NOTICE OF MEETING

A meeting of the **ARGYLL AND BUTE LOCAL REVIEW BODY** will be held in the **COMMITTEE ROOM 1, KILMORY, LOCHGILPHEAD** on **TUESDAY, 12 DECEMBER 2017** at **10:00 AM**, which you are requested to attend.

1. **APOLOGIES FOR ABSENCE**
2. **DECLARATIONS OF INTEREST (IF ANY)**
3. **CONSIDER NOTICE OF REVIEW REQUEST: ERECTION OF DWELLINGHOUSE AND RELOCATION OF SEARCH AND RESCUE SHED AT LAND SOUTH OF 1 LOCHANDHU, TAYNUILT, ARGYLL (REF: 17/0010/LRB)**
 - (a) Notice of Review and Supporting Documentation (Pages 3 - 40)
 - (b) Comments from Interested Parties (Pages 41 - 66)
 - (c) Comments from Applicant (Pages 67 - 68)

Reference No: 17/01745/PP
Planning Hierarchy: Local
Applicant: Mr Tony Huntington
Proposal: Erection of dwellinghouse and relocation of search and rescue shed
Site Address: Land to the south of 1 Lochandhu, Taynuilt

Client Mr T Huntingdon		Telephone 01463 717 799	
Project Proposed House at Lochandhu Taynult		Date May 2017	
Title Proposed Elevations & Floor Plans		Checked ---	
Branch Inverness	Drawn JMF	Scale 1:100	Rev B
Job No. H 5473	Date May 2017	Scale 1:100	Rev B
Dirg No. SK002	Date		Rev B

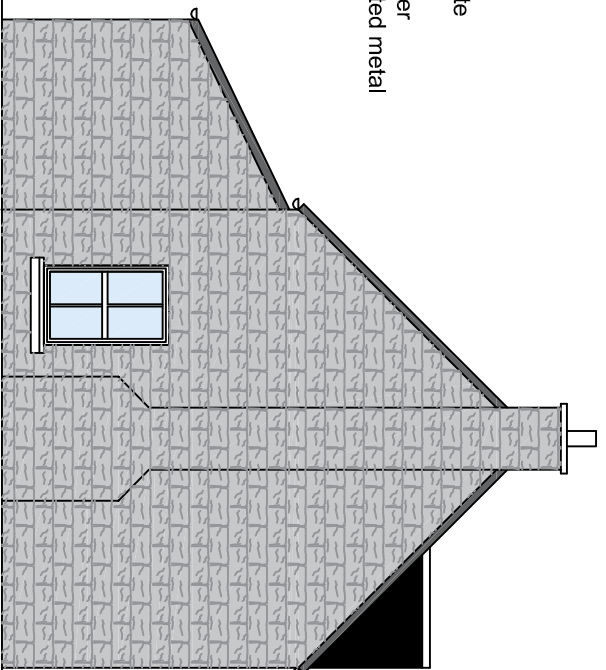
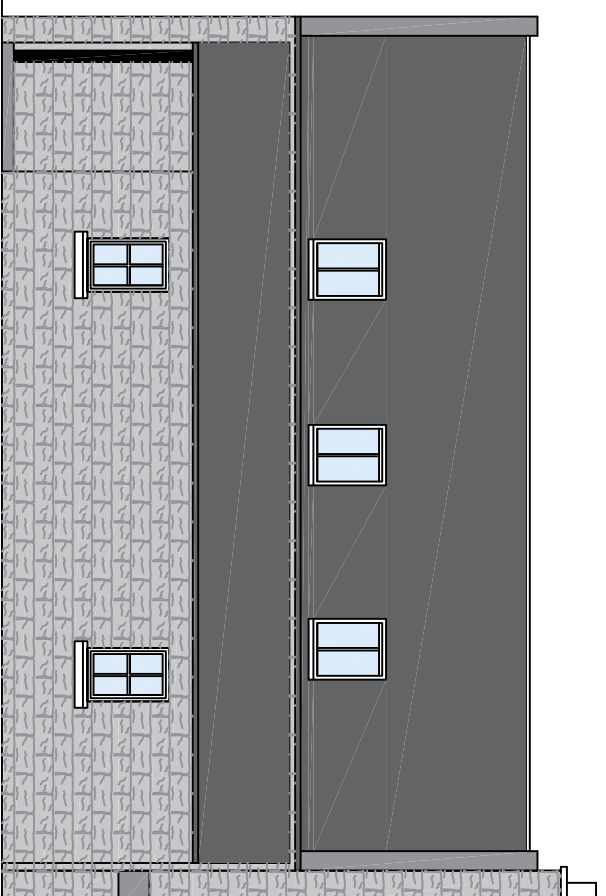
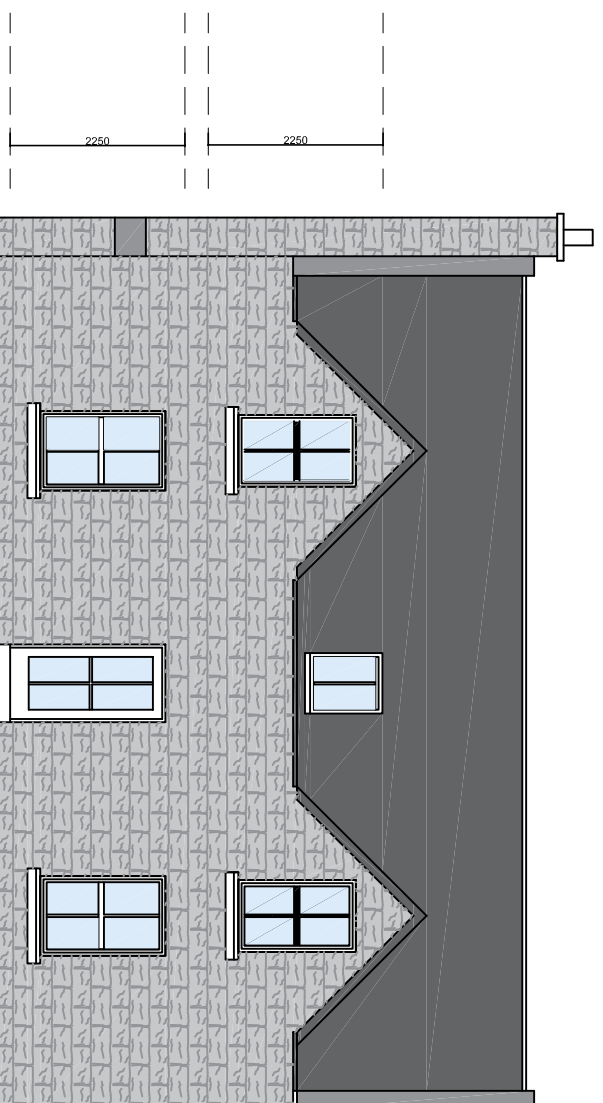
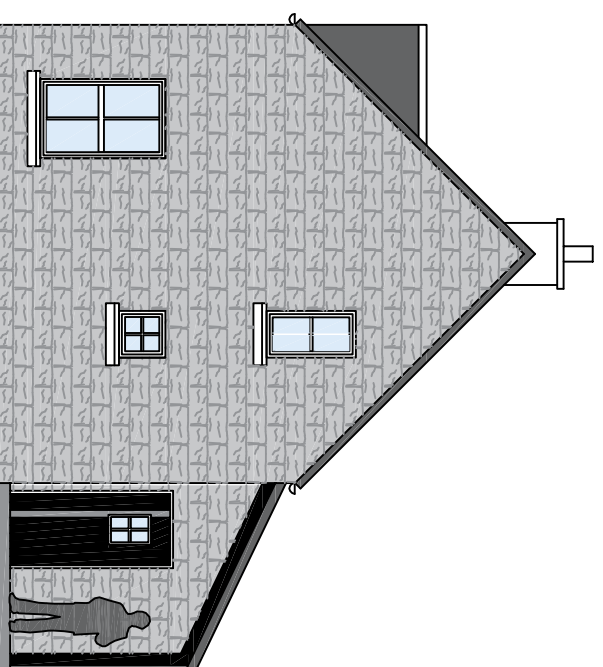
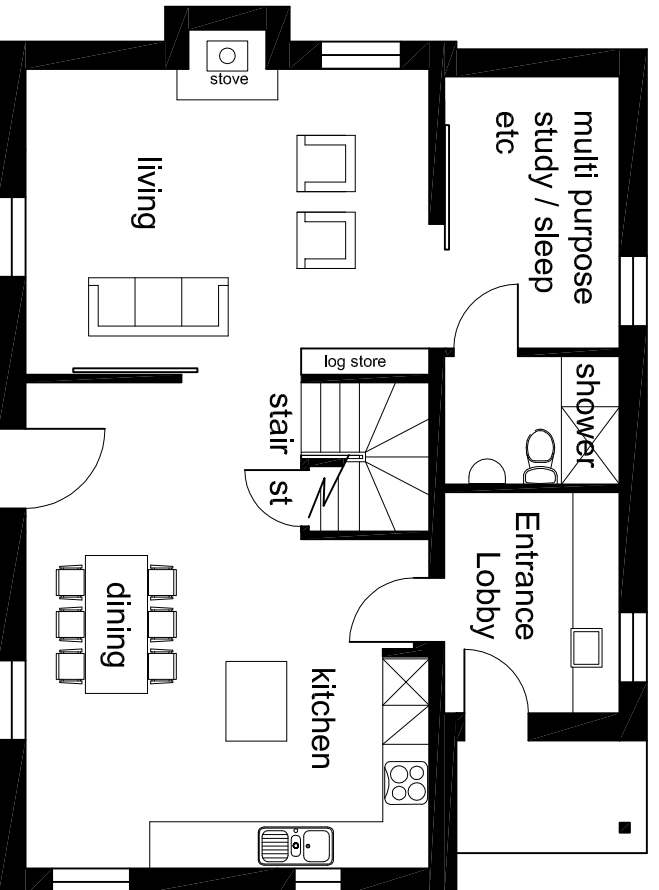
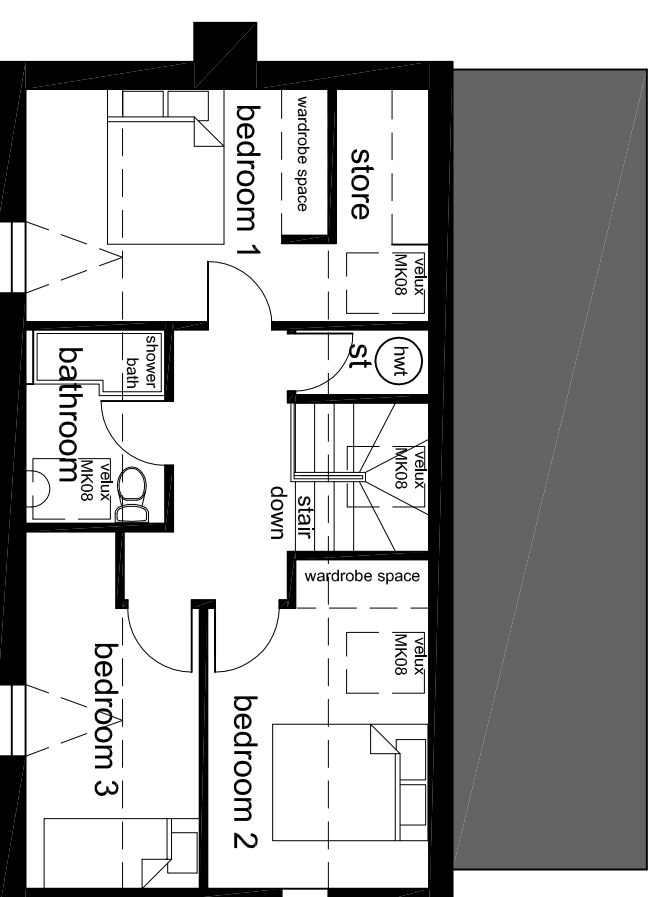
The proposed dwellinghouse which is the subject of this application has a more traditional form and style. It would be one and a half storey in height with a 45 degree pitched roof. The south facing elevation would incorporate 2 wallhead dormers with a number of velux windows being installed into the roof planes. The north facing elevation would incorporate a projection which would run from below the eaves with a mono-pitched roof running the majority of the length of the dwellinghouse. The openings are set cohesively which helps to aid to the dwellinghouses balanced appearance. The roof would be finished with slate and the walls would have a natural stone finish. The proposed dwellinghouse would be more in keeping with the one and a half storey terraced row of houses to the north east of the site. The proposed dwellinghouse is still considered to be relatively incongruous on this site particularly with regards to the impact on the A-listed Terrace at 1-4 Lochandhu to the north.

proposed dwellinghouse at the site has been significantly altered to have a more traditional appearance. However, the proposed dwellinghouse is still considered to be relatively incongruous on this site particularly with regards to the impact on the A-listed Terrace at 1-4 Lochandhu to the north. The roads issues are paramount to this proposal and there is no change to the proposed access regime which could warrant the development of this site.
